23048 - DOTA - HNL PASS/ID OFFICE RENOVATION

PROJ NO. CO1322-63

ADDENDUM #2

DATE: 03/10/23

Rendering - BADGING AREA WORKSTATION TYPICAL

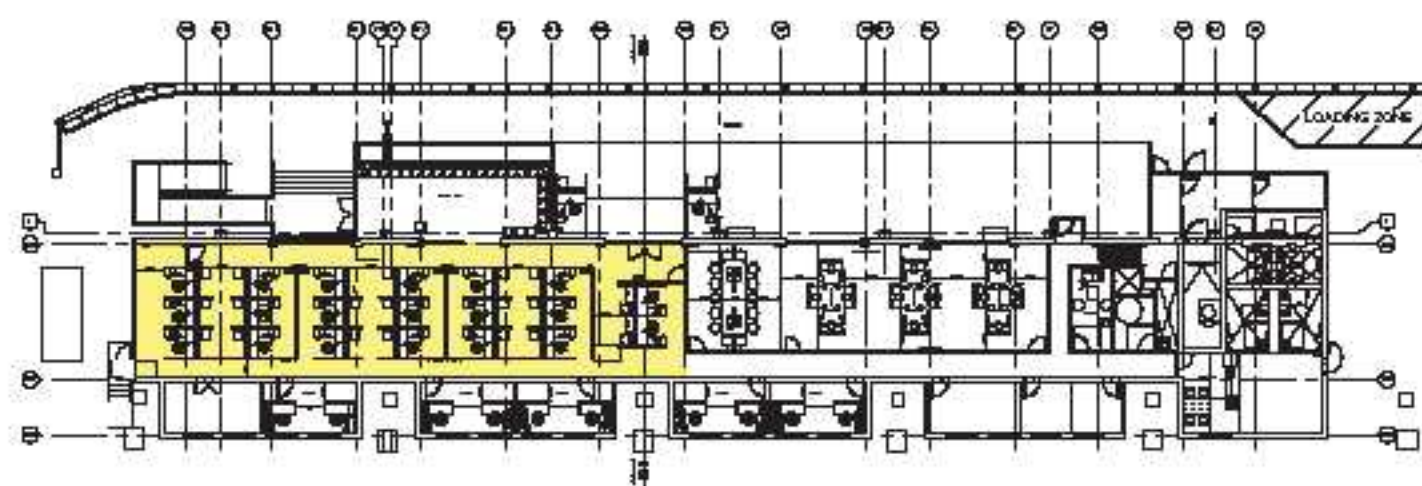
PLEASE REPLACE
POUFS WITH CHAIRS
W/CASTERS SIMILAR
TO MATCH ADA
STATIONS ON
FOLLOWING PAGE.

Rendering - QUEUING AREA

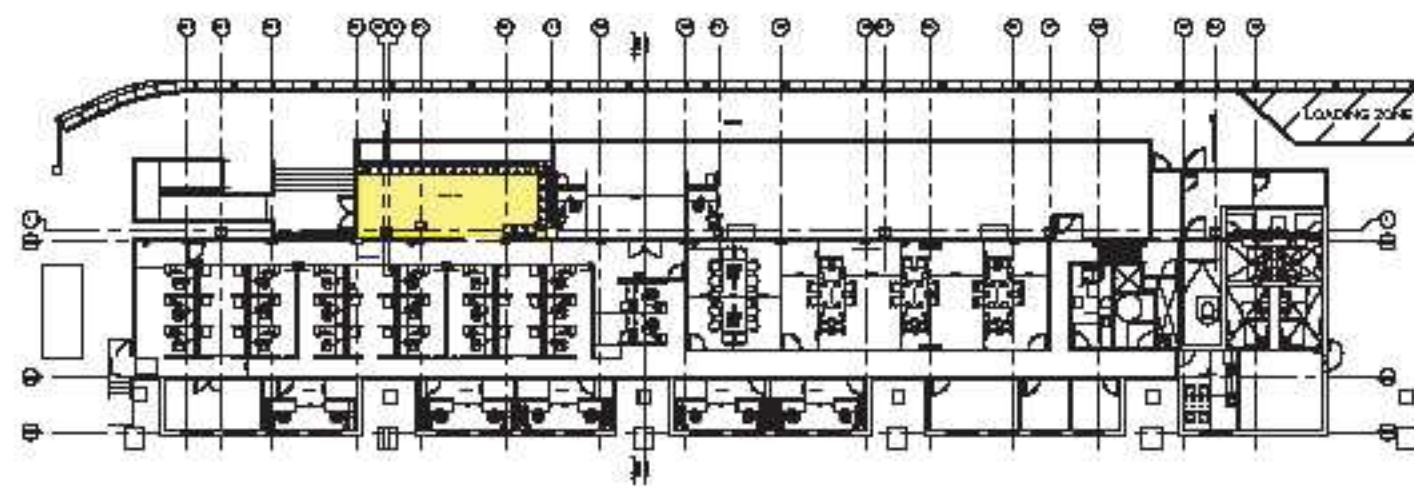
ALL GUEST
CHAIRS TO BE
PLASTIC AND
NESTING

ALL TASK
CHAIRS TO BE
MESH BACK,
FABRIC SEAT W/
ARMS

Rendering - SMALL CONFERENCE

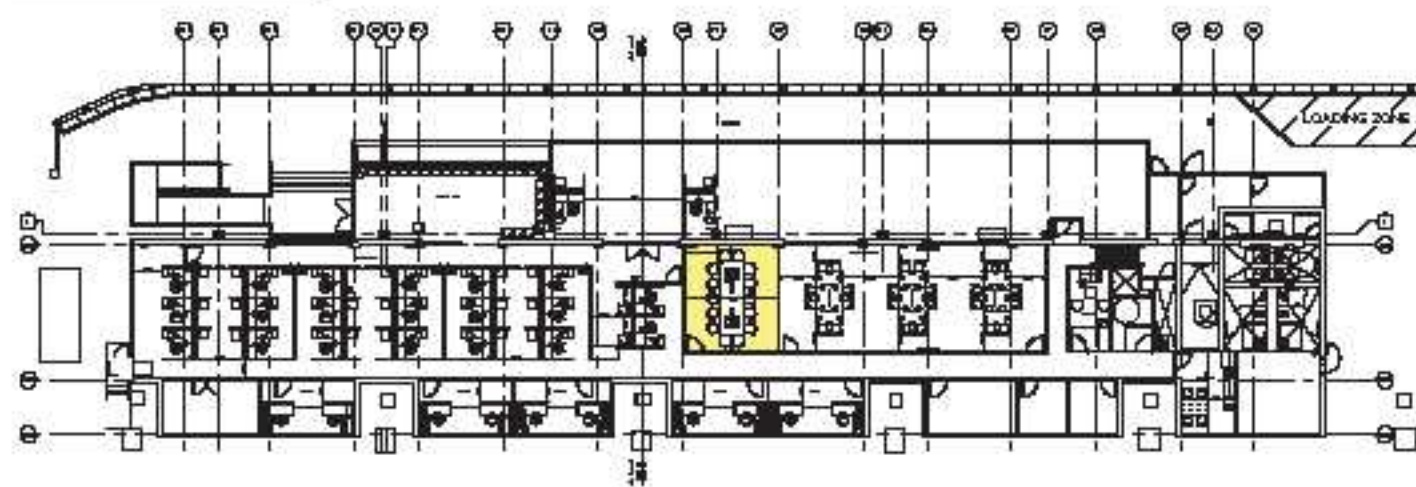
CHAIRS AT
SMALL CONF
ROOM TO BE
MESH BACK,
FABRIC SEATS,
WITH ARMS

Rendering - MAIN CONFERENCE

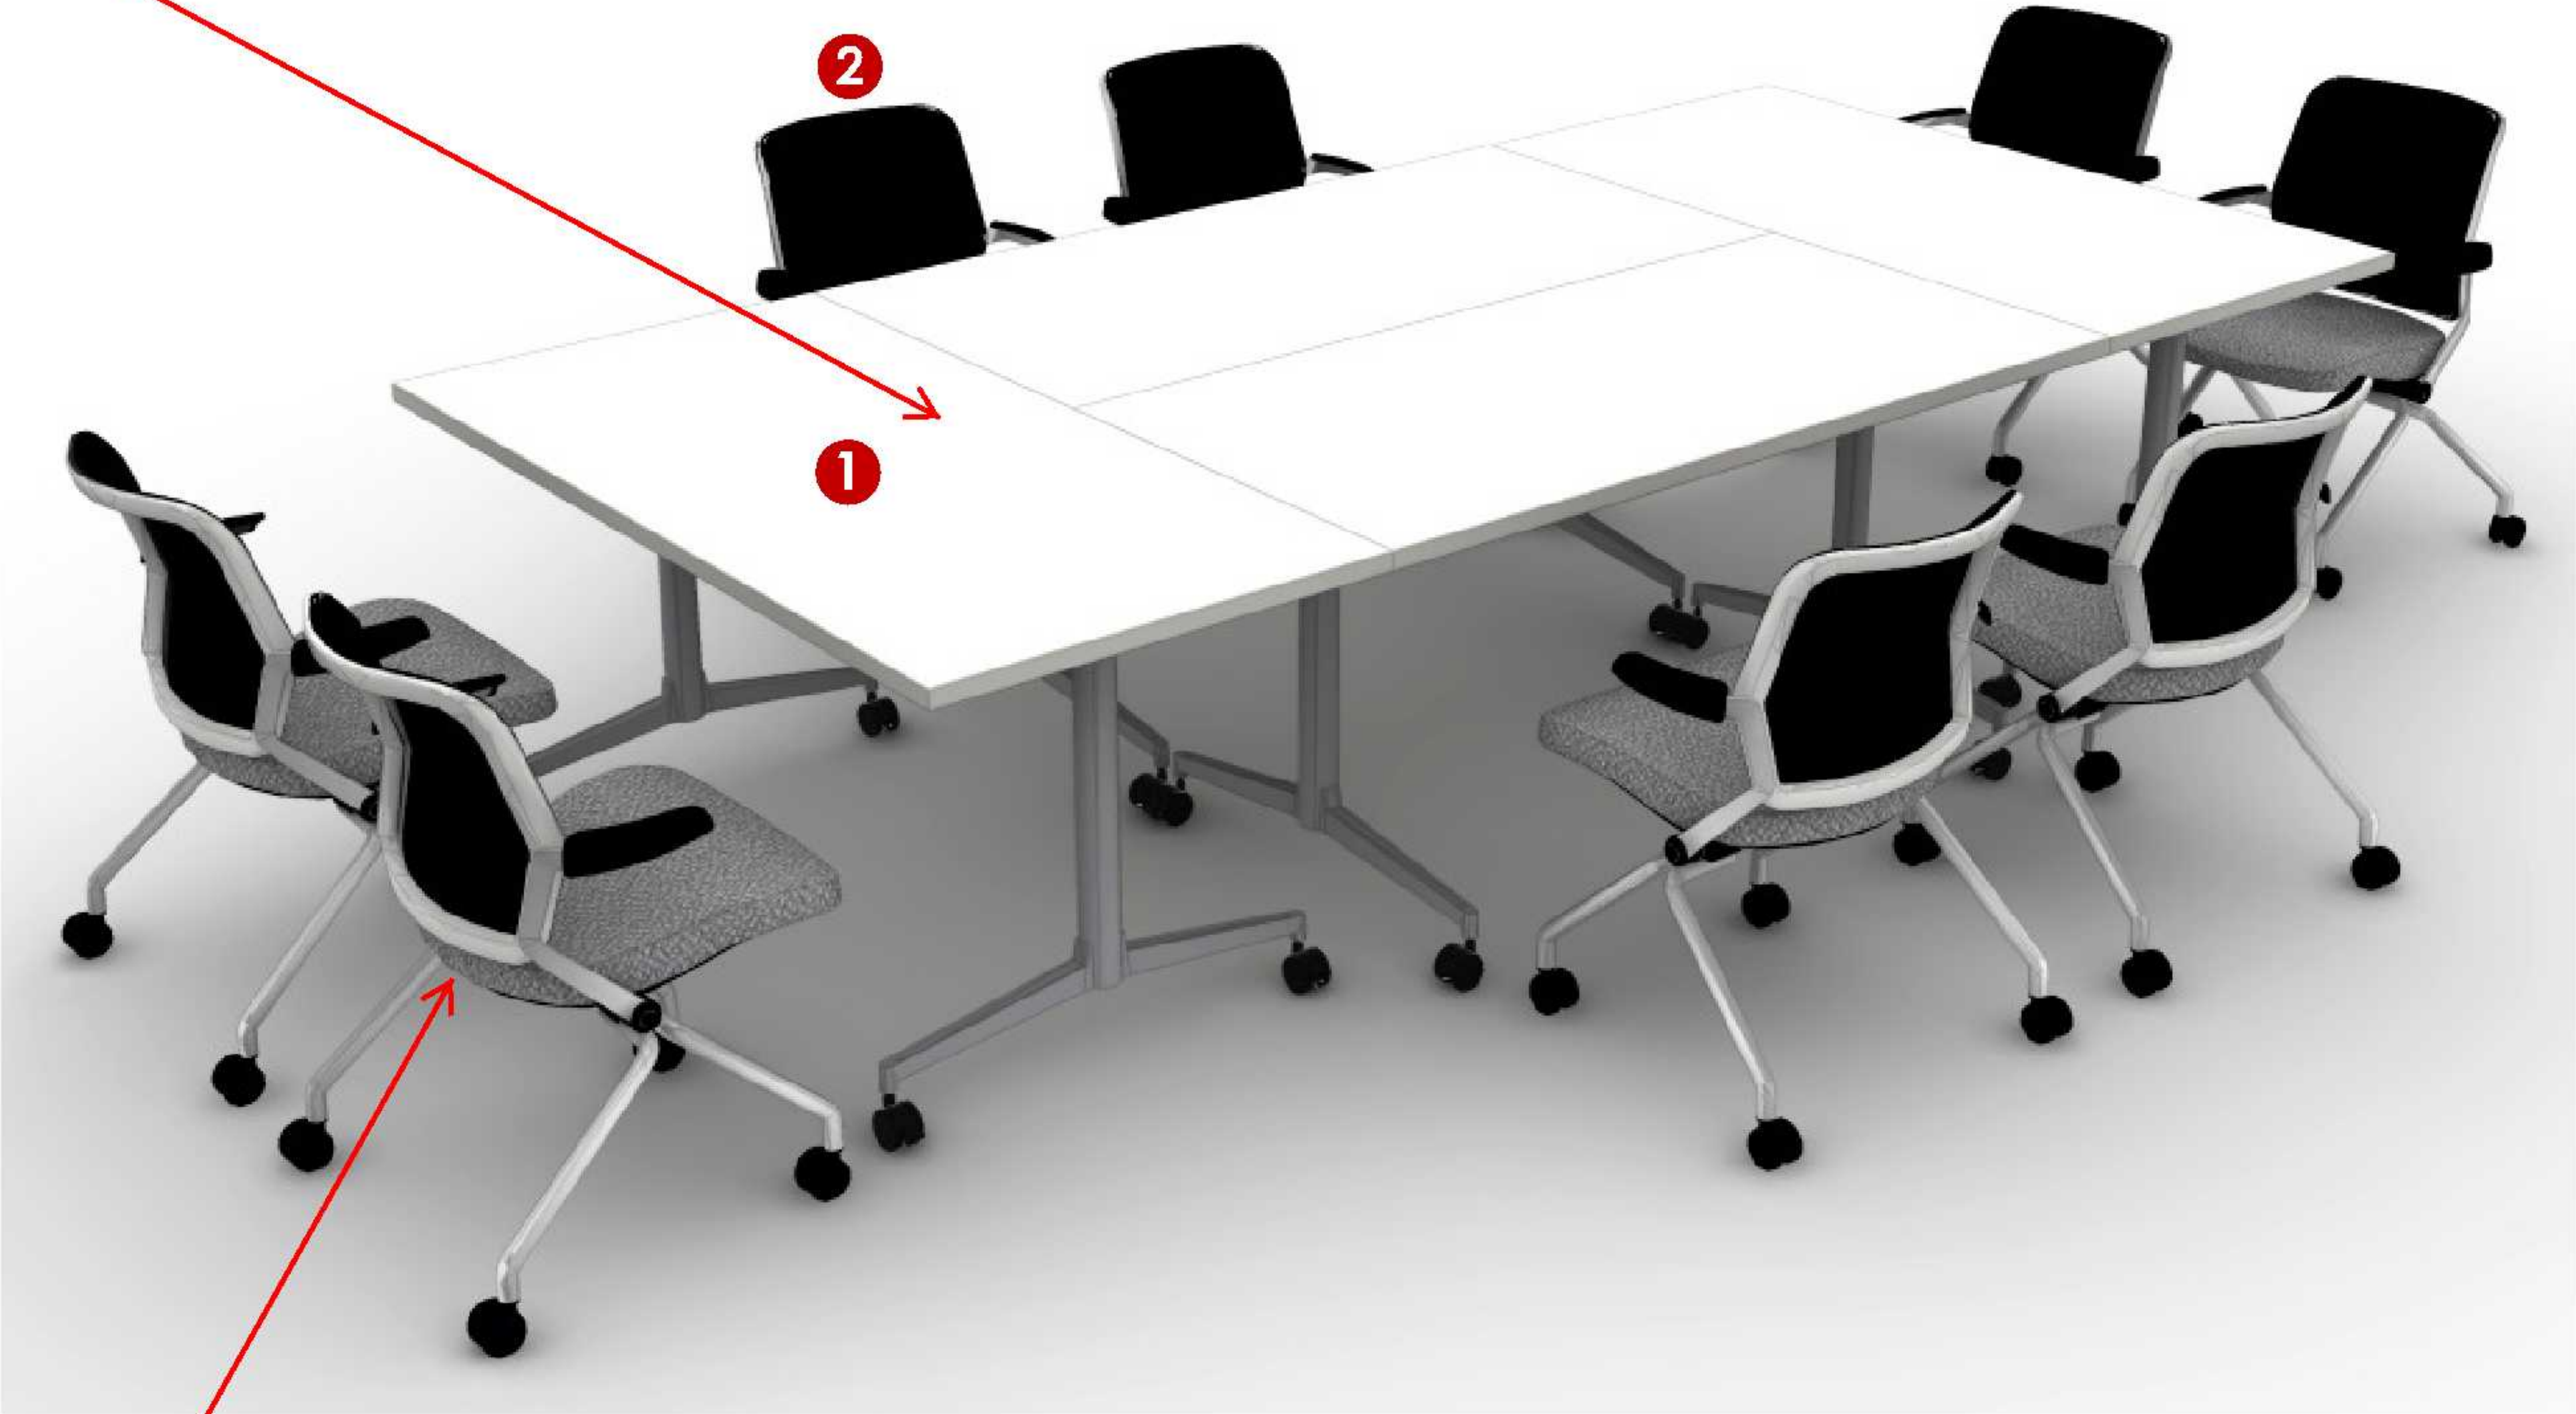
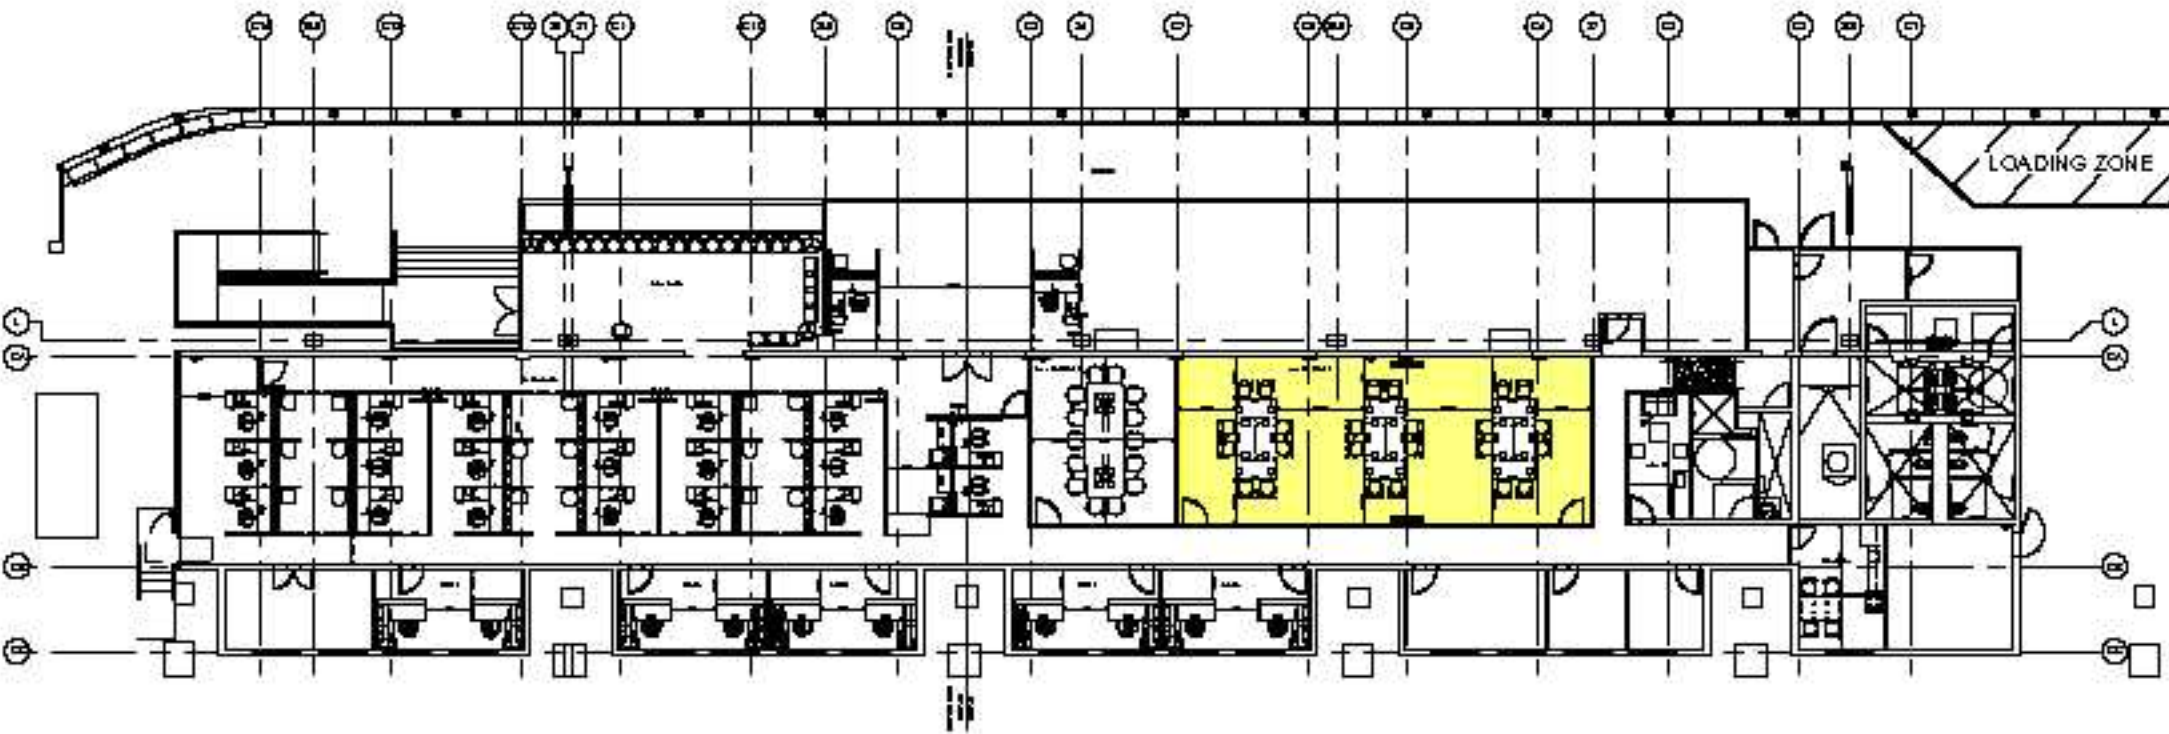
PROVIDE
GROMMET AND
COVER AT EACH
TABLE

CHAIRS AT MAIN
CONF ROOM TO
BE SEMINAR/
TRAINING TYPE
W/MESH BACK,
FABRIC SEAT
AND ARMS
